## **Attachment 2**

### **Changes to Information and Documents Provided in March 9, 2018 License Amendment Request (LAR)**

As noted in the cover letter to this LAR supplement, due to changes made to planned modification MP 16-0024 and from resolution of items identified during the NRC's September 2018 audit at Callaway, some of the information and documents provided in the original March 9, 2018 LAR (i.e., Ameren Missouri letter ULNRC-06401, "License Amendment Request for Addition of New Technical Specification 3.7.20, 'Class 1E Electrical Equipment Air Conditioning (A/C) System' (LDCN 16-0013)," dated March 9, 2018) have been changed. Changes from the original LAR, along with descriptions and explanations of the changes, are identified in the enclosed pages of this attachment.

### 3.2.3 Results

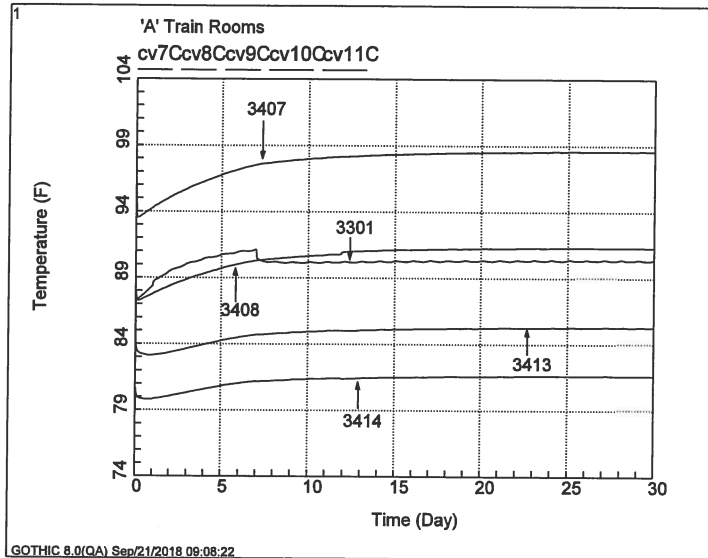
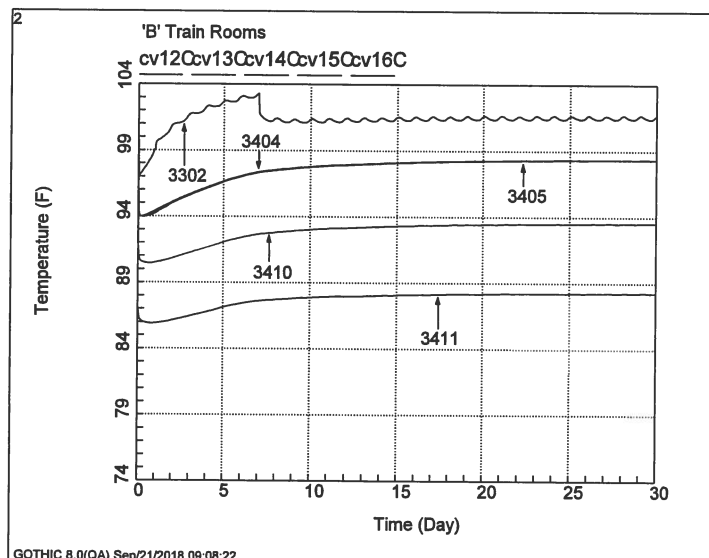
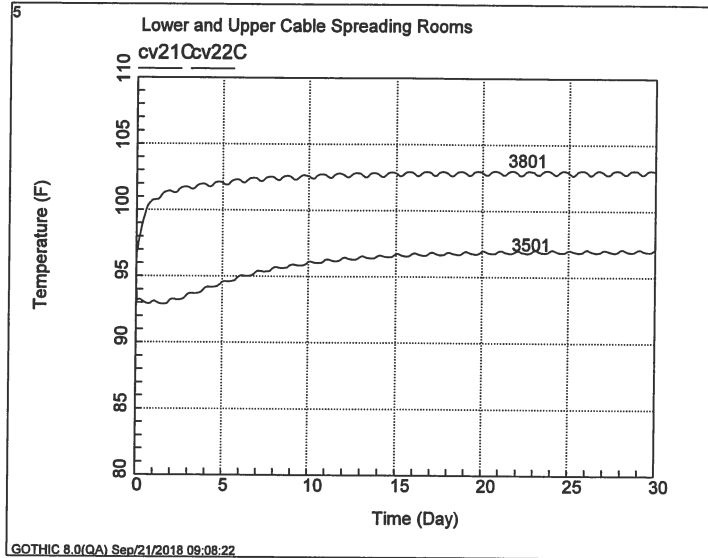
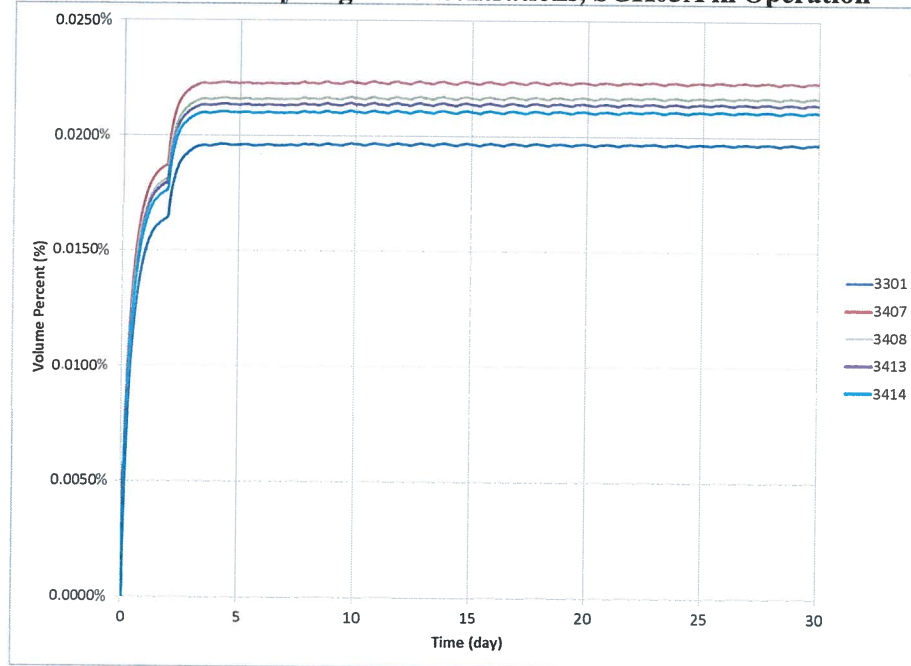
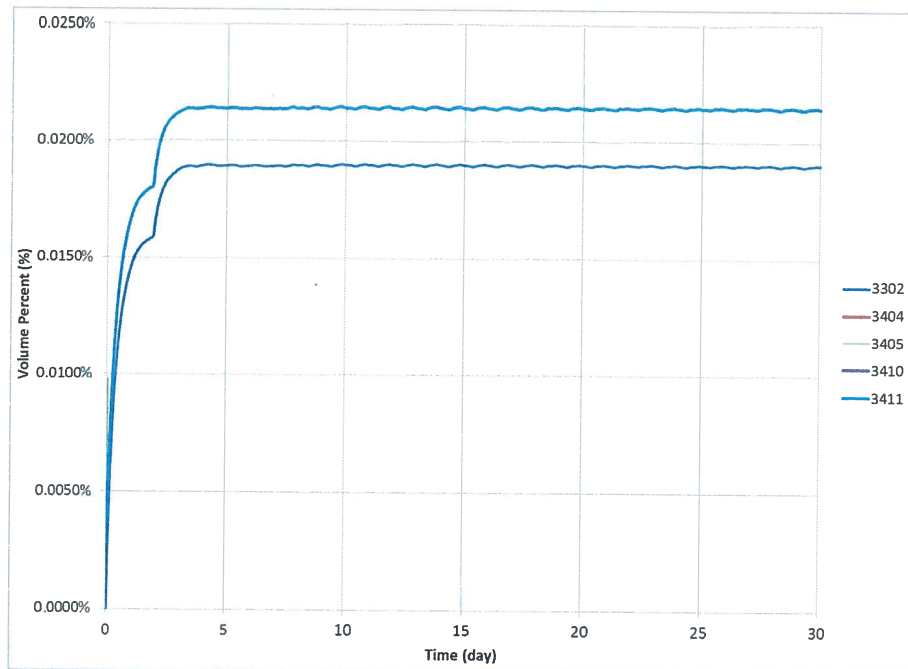
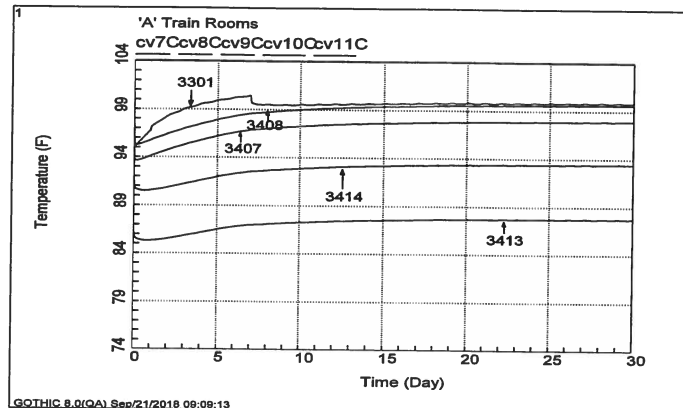
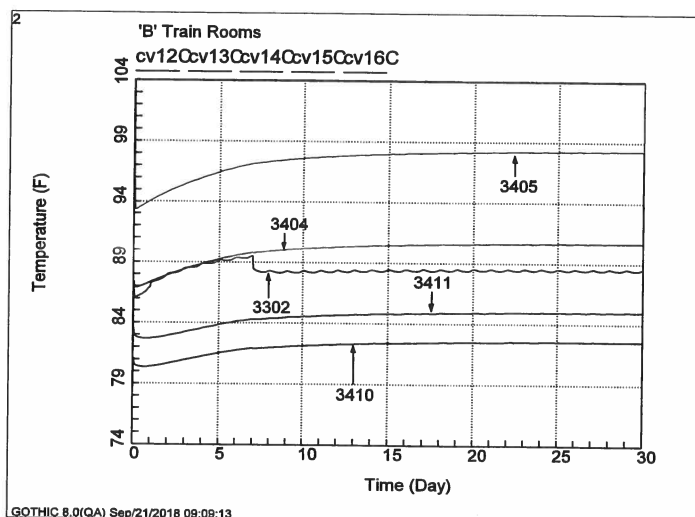
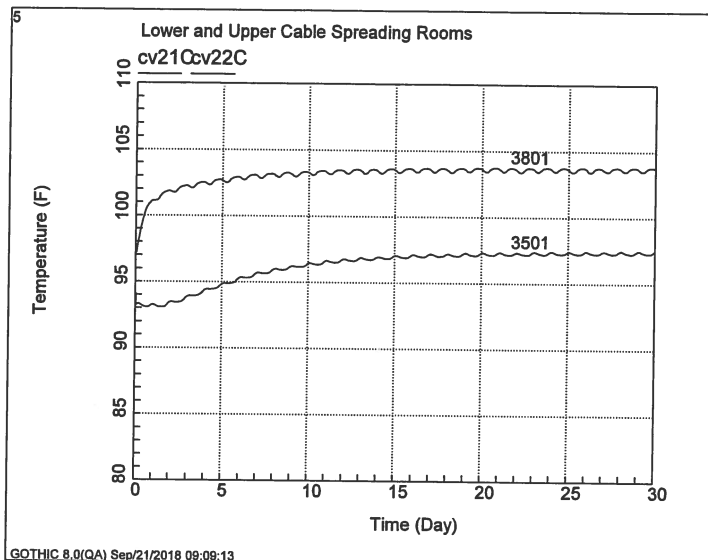
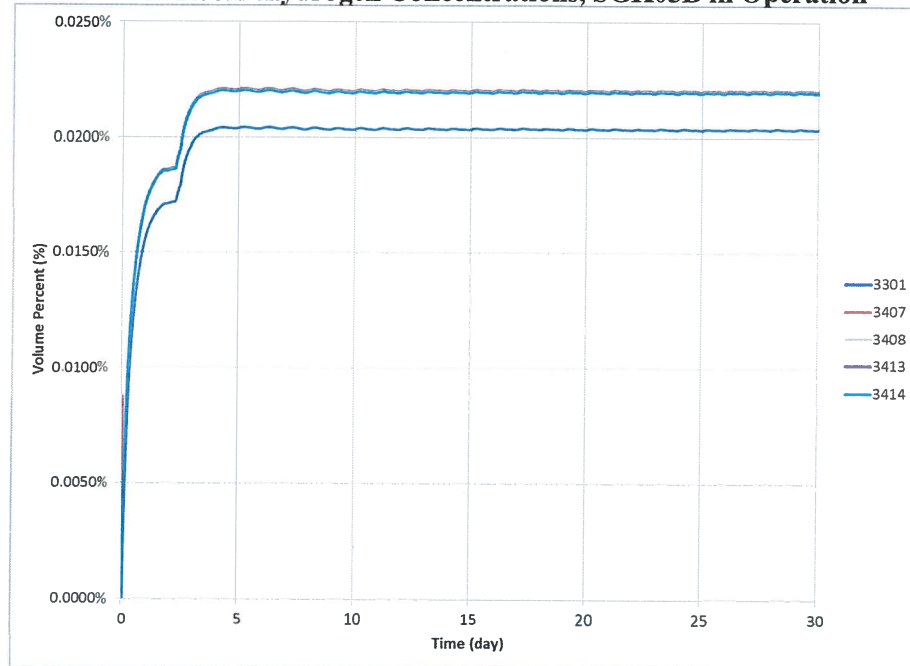
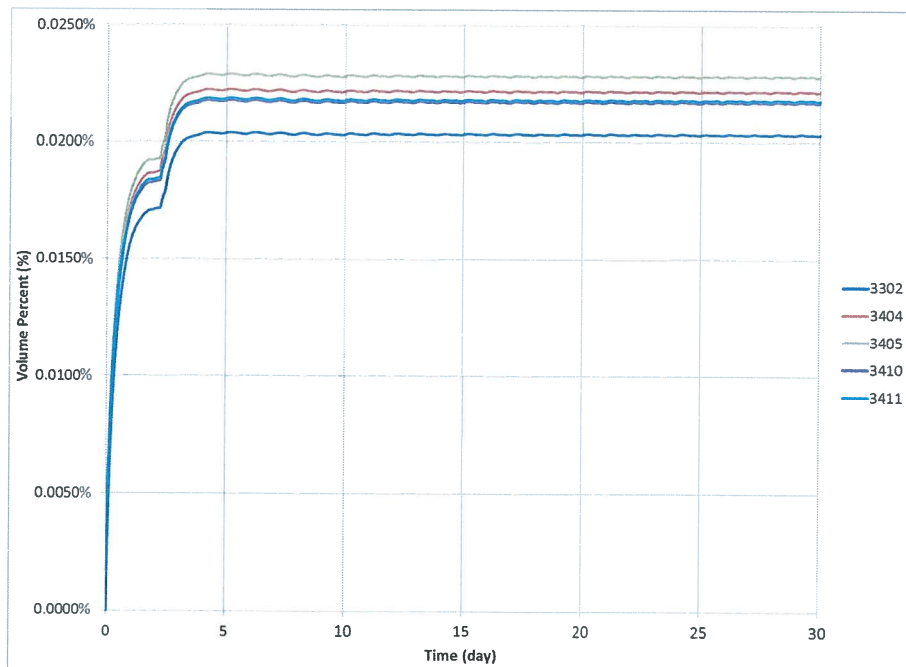
**Change No. 3:** Updated results (temperature and hydrogen concentration information) from Revision 1 of the GOTHIC calculation.

In Attachments 1 and 2 of the LAR, in Section 3.2.3, "Results," (pages 17 through 23), a summary of results from the supporting GOTHIC (heat-up) calculation was presented, including a number of figures/graphs showing the maximum room temperatures and hydrogen concentrations reached for various analyzed conditions/cases.

As already noted (for Change No. 2), GOTHIC calculation NAI-1719-004, Revision 1, was approved in October 2018. Revision 1 of this document implements the new "up-and-over" ductwork design for the supply side of cross-tie fans CGK07A/B and relocates the transfer grills between Rooms 3404, 3405, 3407, and 3408 from the walls to the doors between these rooms. From the results of Revision 1 of the calculation, Table 4 in originally provided Section 3.2.3 should be updated with the revised temperatures. In addition, the maximum hydrogen concentration specified on page 18 of the LAR should be changed from 0.0221% to 0.0229%.

**Required Change:** The figures and graphs originally provided in Section 3.2.3 of Attachments 1 and 2 of LAR require revision, though the changes are discreet. To reflect these changes, all of Section 3.2.3 is repeated below with updated numbers and figures/graphs. Thus, Section 3.2.3 provided below should be regarded as superseding Section 3.2.3 in the original LAR.
